SUBJECT: NORTH ANNA POWER STATION, UNITS 1 AND 2 - STAFF ASSESSMENT OF INFORMATION PROVIDED PURSUANT TO TITLE 10 OF THE *CODE OF FEDERAL REGULATIONS* PART 50, SECTION 50.54(f), SEISMIC HAZARD REEVALUATIONS RELATING TO RECOMMENDATION 2.1 OF THE NEAR-TERM TASK FORCE REVIEW OF INSIGHTS FROM THE FUKUSHIMA DAI-ICHI ACCIDENT (TAC NOS. MF3797 AND MF3798)

STAFF ASSESSMENT BY THE OFFICE OF NUCLEAR REACTOR REGULATION

RELATED TO SEISMIC HAZARD AND SCREENING REPORT

NORTH ANNA POWER STATION, UNITS 1 AND 2

Figure 3.3-1: Plot of Staff's and Licensee's Base Case Shear-Wave Velocity Profile for the NAPS site

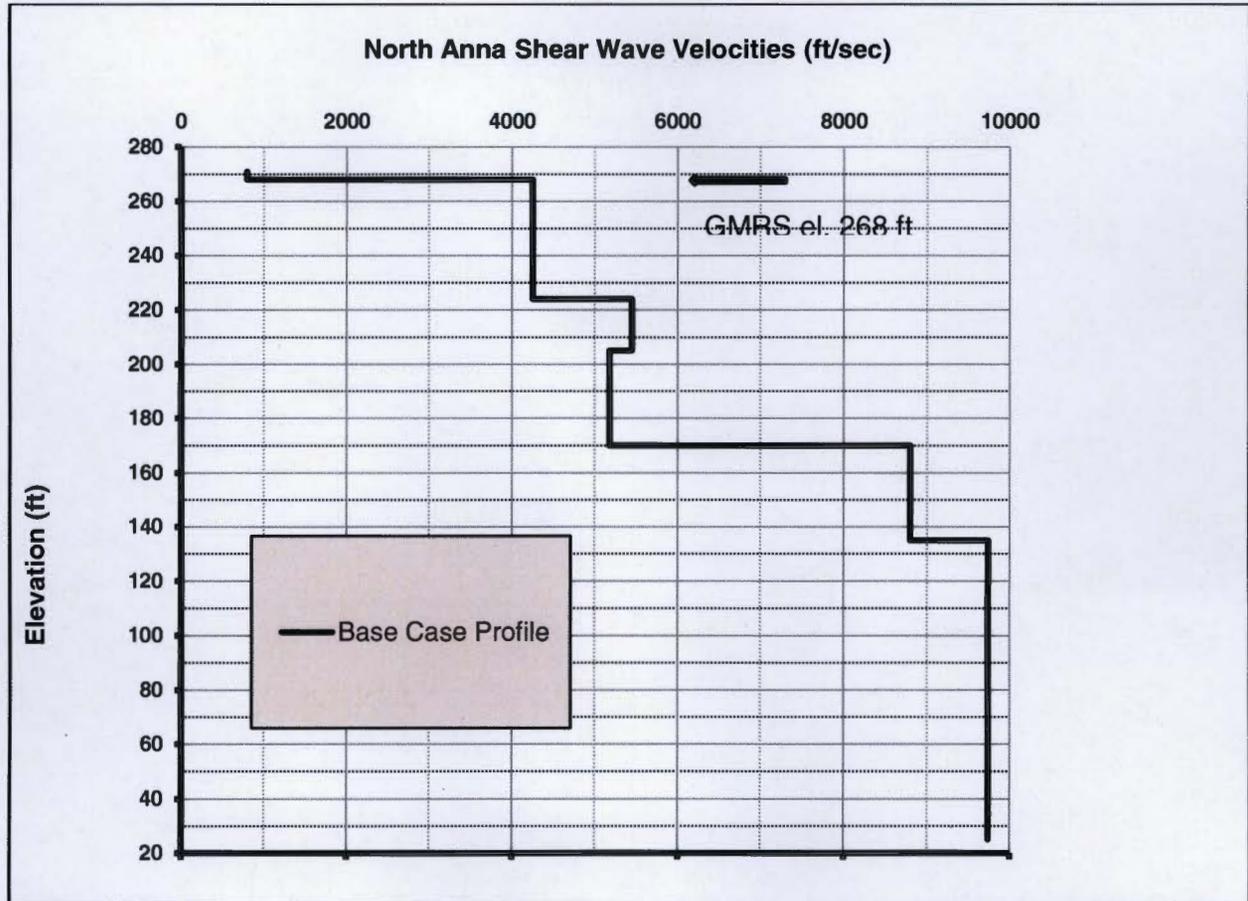
To confirm the licensee's site response analysis, the staff performed site response calculations for the NAPS site. For the confirmatory analysis, the staff calculated the site response using most of the licensee's inputs because the site is well characterized and the licensee used information based on actual detailed site investigations. For its site response calculations, the staff employed the RVT approach and developed input ground motions in accordance with Appendix B of the SPID. Figure 3.3-1 of this assessment shows the best case shear wave velocity profile used by both the licensee and staff for the site response analysis.

Figure 3.3-2 Plot Comparing the Staff's and the License's Median Amplification Functions and Uncertainties for two input loading levels for the NAPS site

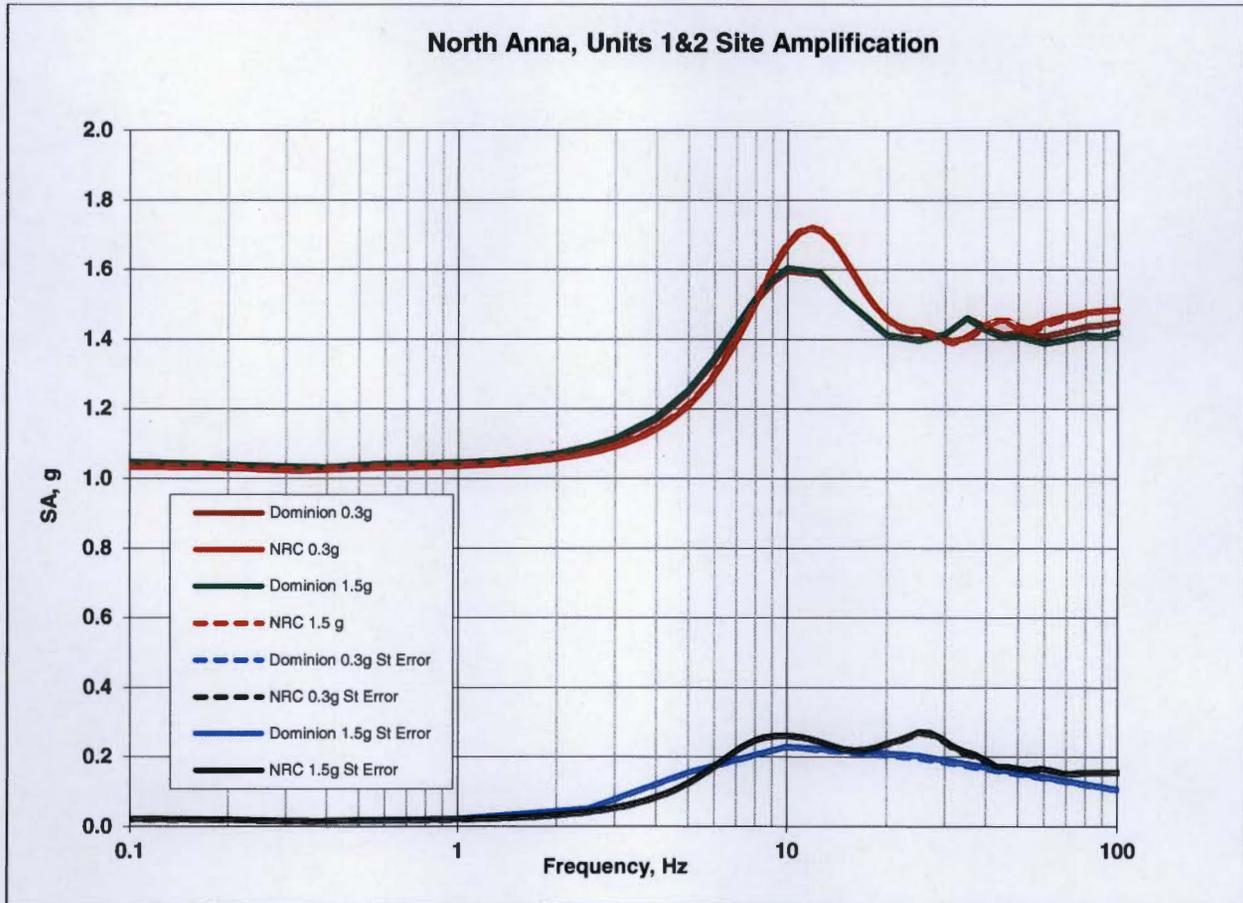
Figure 3.3-2 shows a comparison of the staff's and licensee's median site amplification factors and uncertainties ( $\pm 1$  standard deviation) for two of the eleven input loading levels. The staff's median site amplification factors are very similar to the licensee's with values close to 1 and a modest peak of about 1.7 at 10 Hz. In addition, the staff's calculated amplification factor uncertainties are very similar to those of the licensee's.

Overall, the licensee's approach to modeling the subsurface rock properties and their uncertainty results in very similar site amplification factors relative to the staff's results. Consequently, as shown in Figure 3.3-3 of this assessment, the control point seismic hazard curves developed by the licensee and staff are also very similar. Appendix B of the SPID provides guidance for performing site response analyses, including capturing the uncertainty for sites with less subsurface data; however, abundant data exists for the NAPS site. As such, alternative approaches in performing site response analyses, including the modeling of uncertainty, are acceptable for the 50.54(f) response.

Figure 3.4-1 Comparison of the Staff's GMRS, Licensee's GMRS, and the NAPS SSE

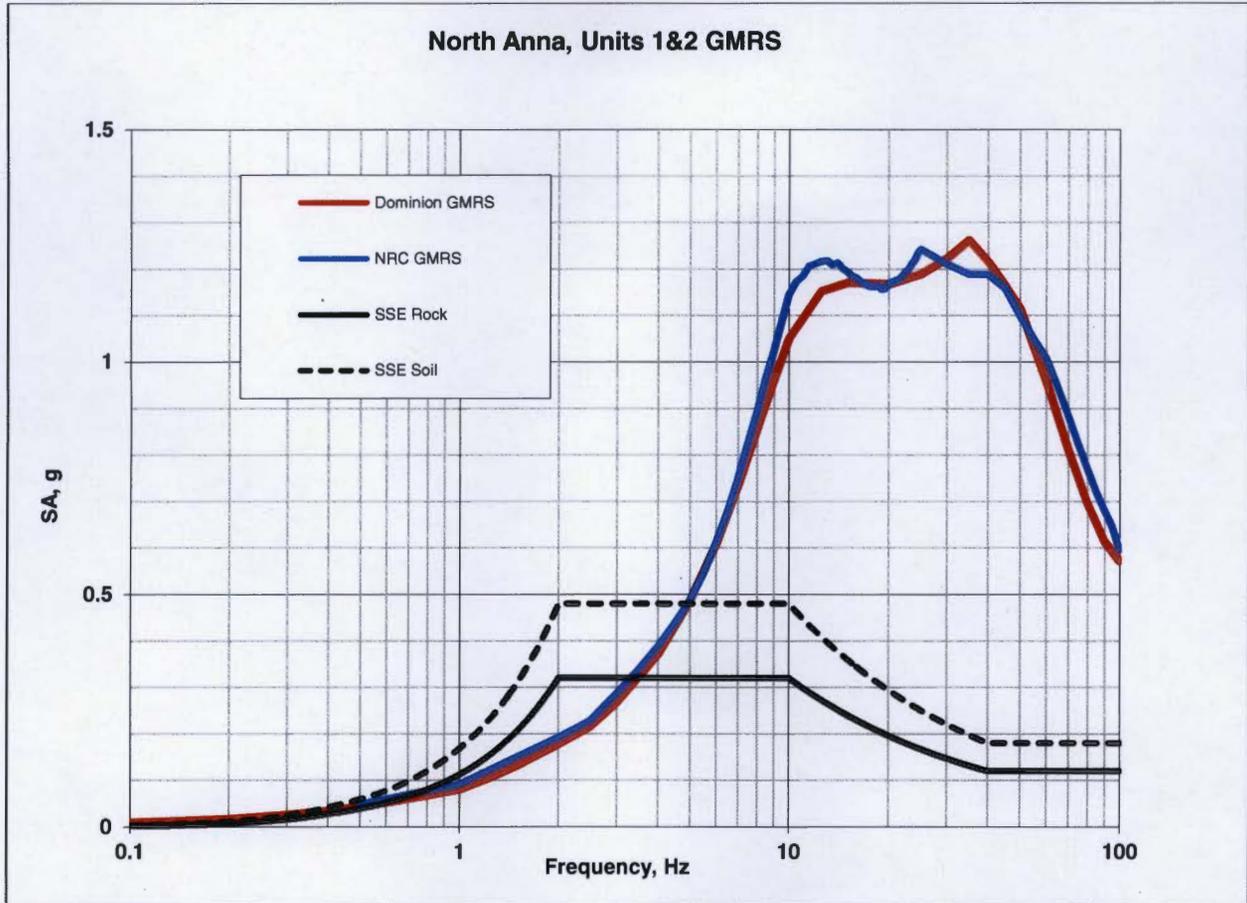
The staff independently calculated the  $10^{-4}$  and  $10^{-5}$  UHRS using the results of its confirmatory PSHA and site response analyses, as described in Sections 3.2 and 3.3 of this staff assessment, respectively. Figure 3.4-1 of this assessment shows a comparison of the GMRS determined by the licensee to that determined by the staff.

As shown in Figure 3.4-1 of this assessment, the licensee's GMRS is very similar to the staff's confirmatory GMRS. The staff concludes that the small differences between the two GMRS are acceptable for this application because the licensee followed the guidance provided in the SPID with respect to both the PSHA and site response analysis for the NAPS site.

The staff confirms that the licensee used the present-day guidance and methodology outlined in RG 1.208 and the SPID to calculate the horizontal GMRS, as requested in the 50.54(f) letter. The staff performed both a PSHA and site response confirmatory analysis and achieved results consistent with the licensee's horizontal GMRS. As such, the staff concludes that the GMRS
